INTERIOR RENOVATIONS
to the
TRUMBULL POLICE DEPARTMENT
158 EDISON ROAD
TRUMBULL, CONNECTICUT

RFP #6320

December 13, 2018

END OF ADDENDUM NO. 1

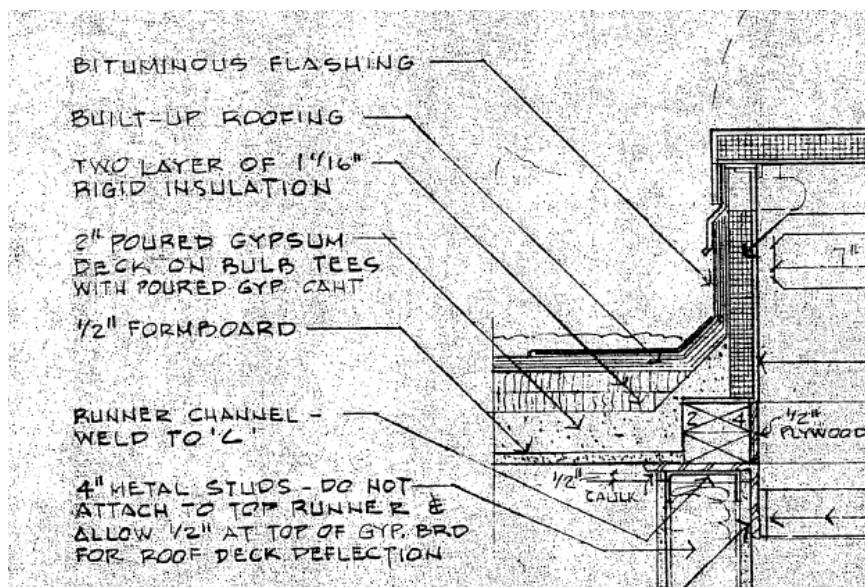
Question: What is the existing roofing composition? Membrane, insulation type and thickness, type of roof deck, etc.

Answer: Drawings from the original construction indicate the following roofing composition: Built-up roof construction over 2-1/8" rigid insulation over poured gypsum on 1/2" form board. Detail illustration below.

FLOW AND CONTROL DIAGRAMS - MECHANICAL

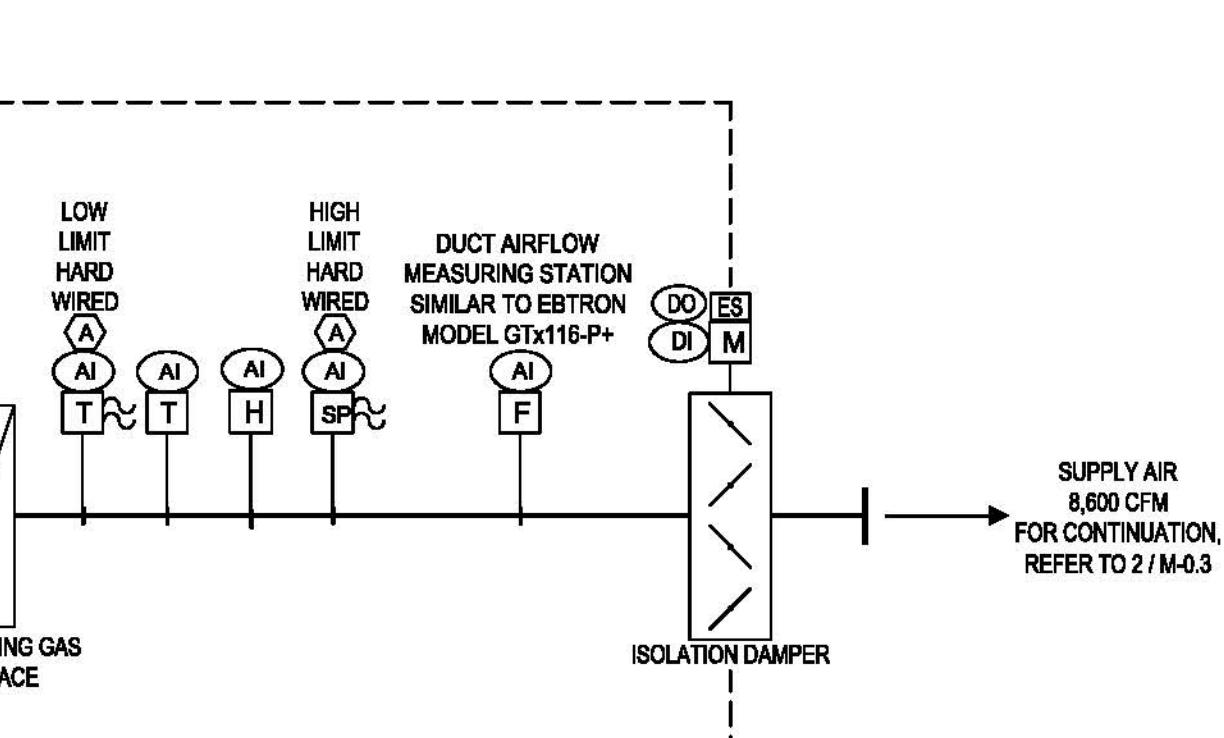
CHANGES TO DRAWINGS**M-0.3 - FLOW AND CONTROL DIAGRAMS - MECHANICAL**

See attached revised drawing with the following revisions incorporated:

- Removed Ebtron flow meters on HVAC-4 RA and SA, flow meters shall be provided by unit manufacturer
- Removed HVAC-4 dashed line for clarification

ROOF PLAN- ELECTRICAL

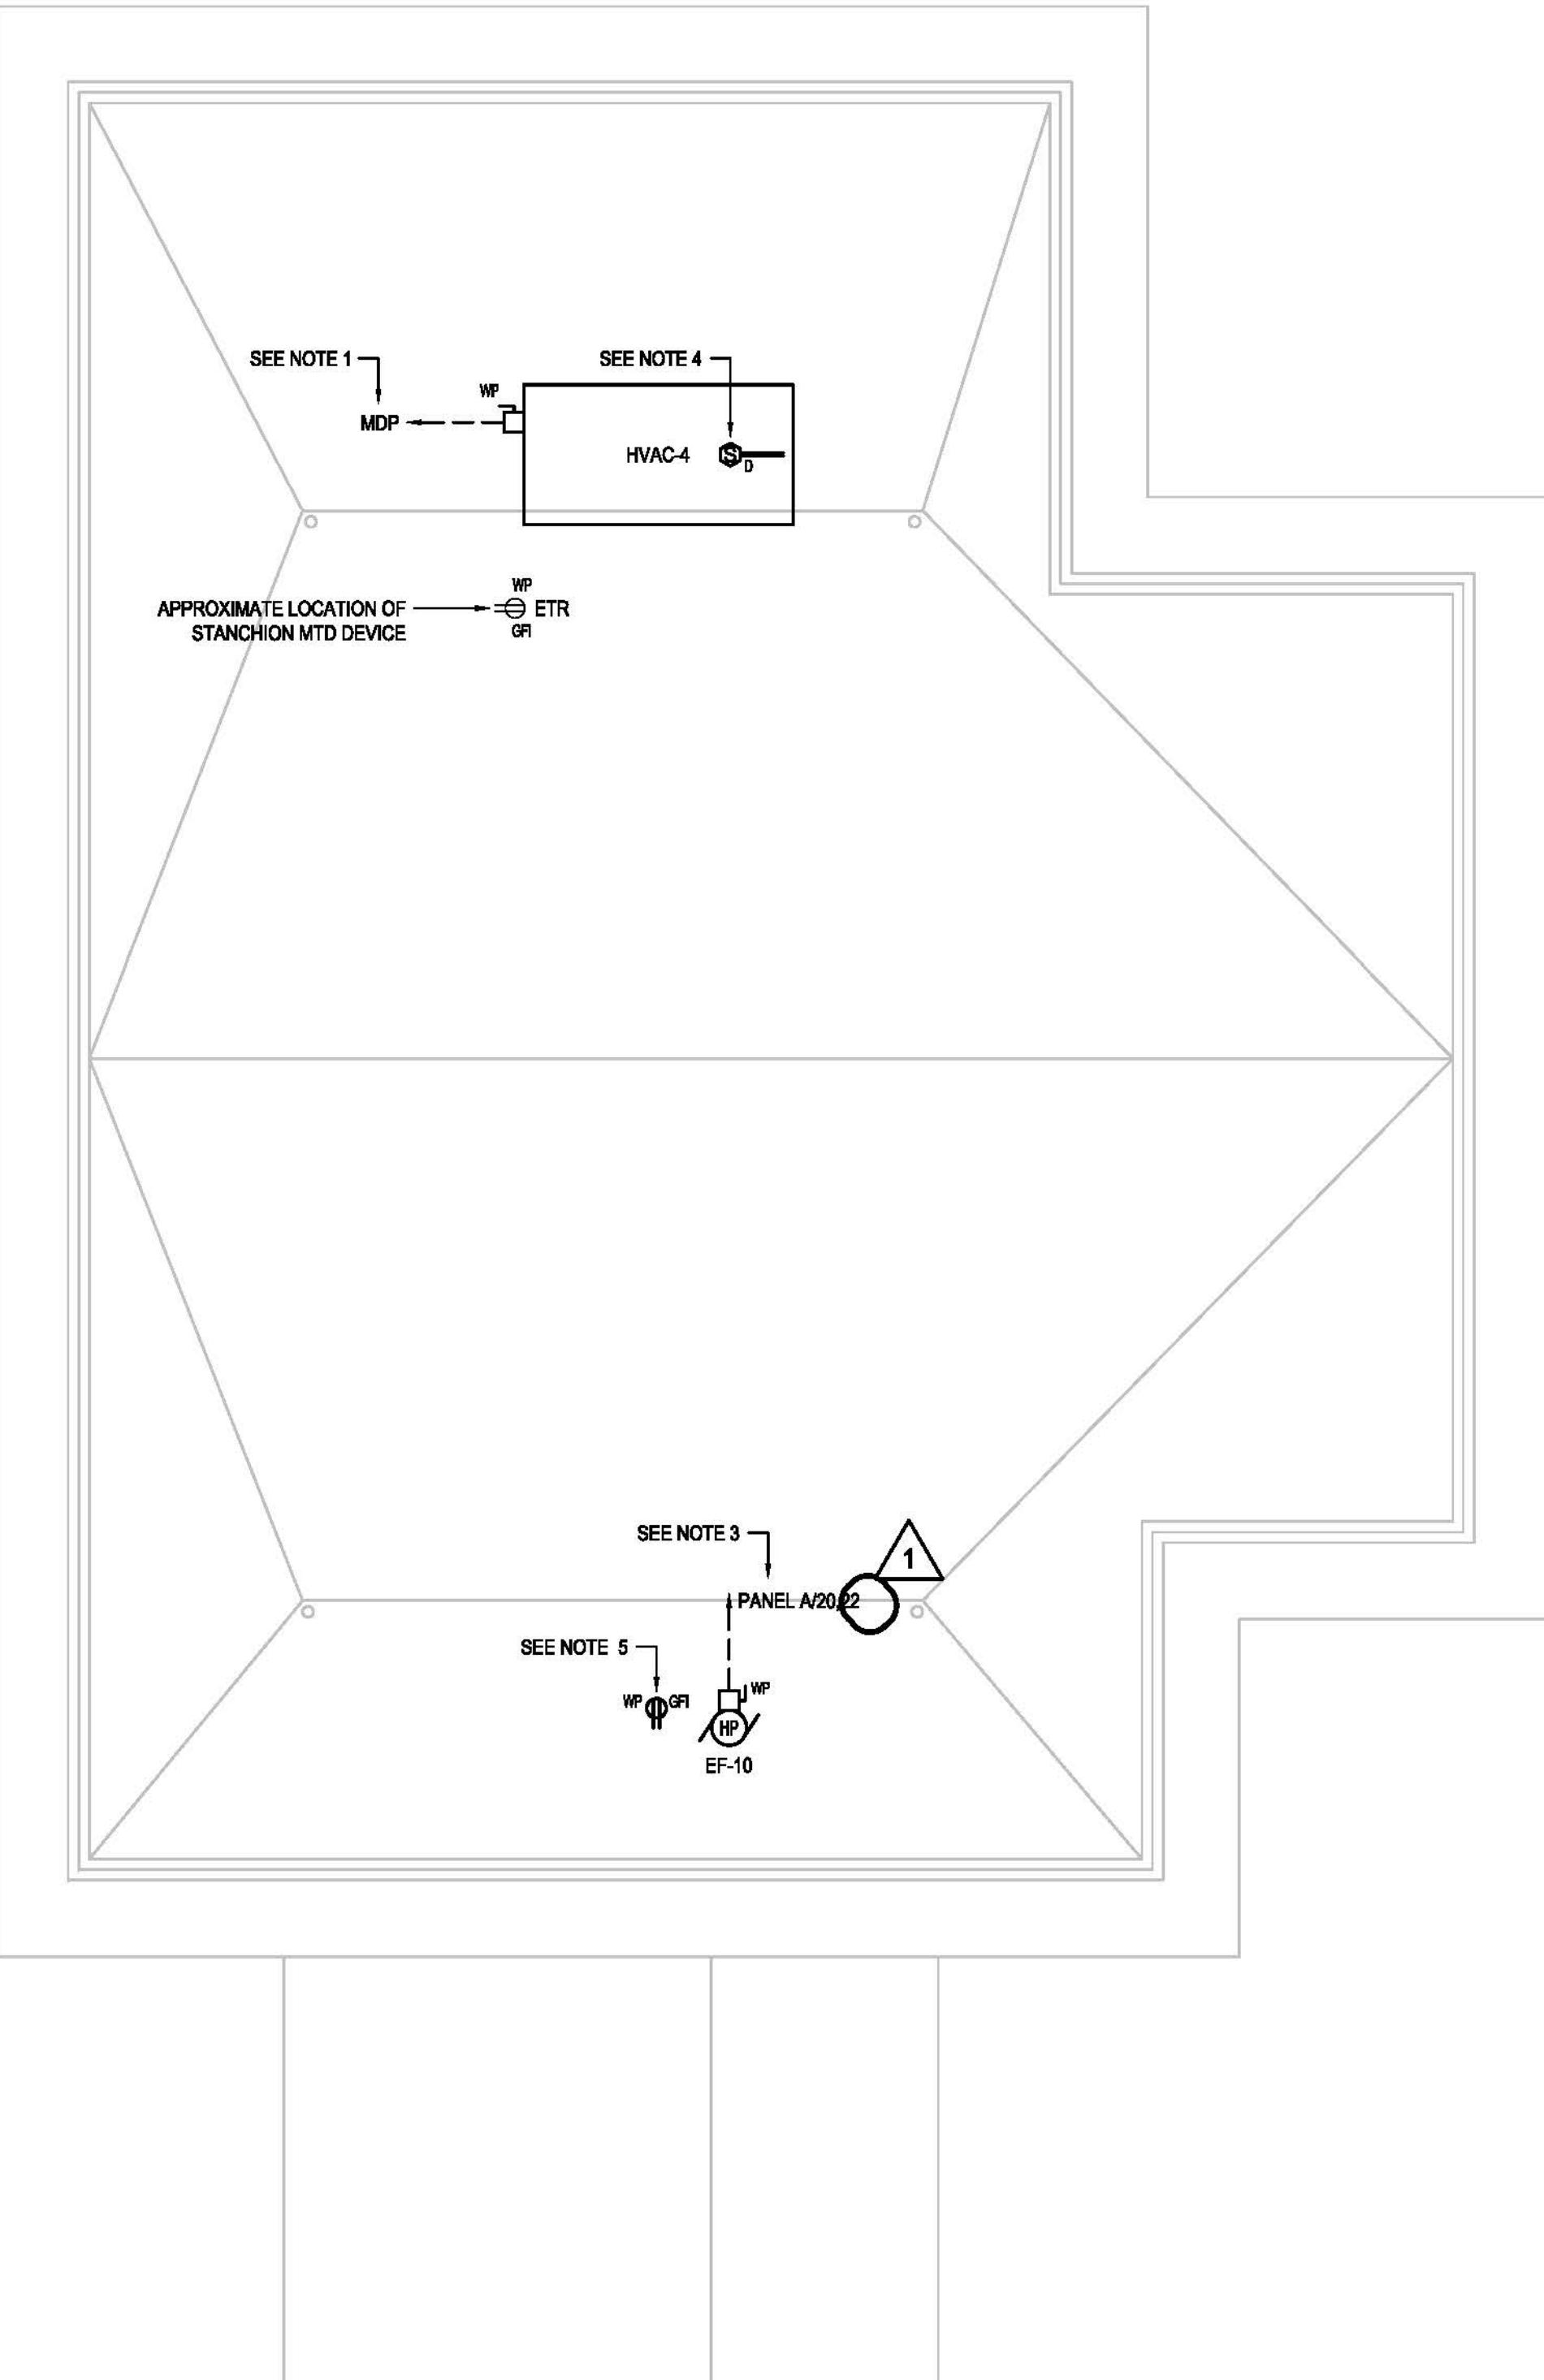
E-1.2 – ROOF PLAN - ELECTRICAL

See attached revised drawing with the following revisions incorporated:

- Revised fan EF-10 branch circuit and circuit breaker to correspond with a 208V, 1Ø load
